PROP-006 rev A

35 Liverpool Road
 Proposed Rear Elevation
 Scale - 1 to 50 @ A3
 17 January 23

Rear (South) Elevation 1:50

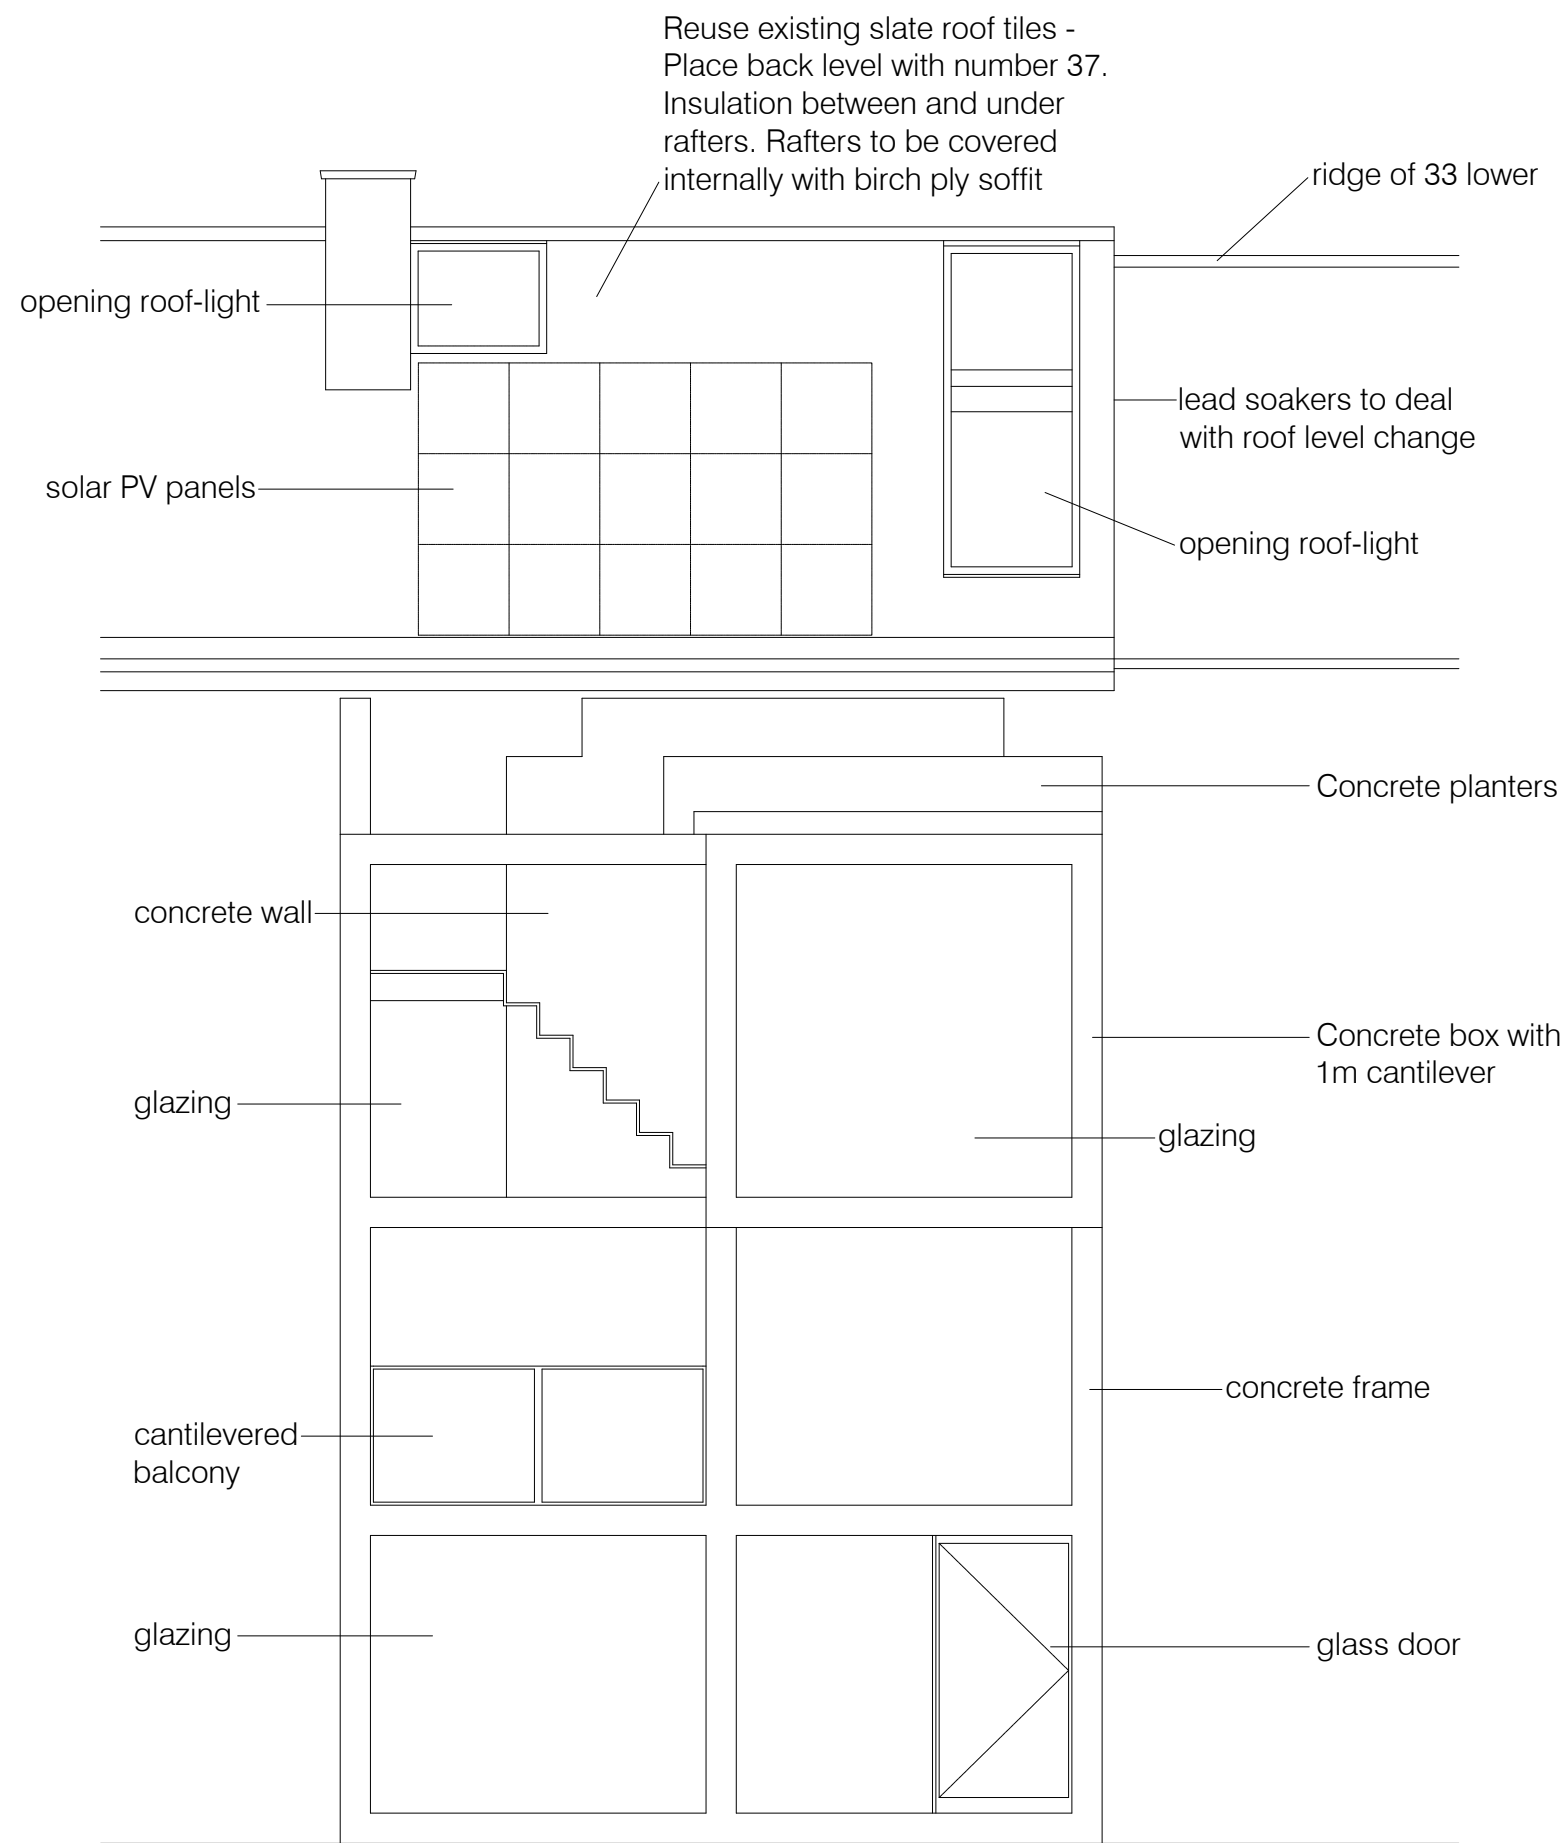
Revisions - External access through existing roof - removed
 Stair from existing roof to new extension roof omitted
 Glass lantern removed
 Heritage roof-lights added to rear of roof
 Alterations to existing purlins omitted
 Position of insulation lowered so slate tiles remain at existing level
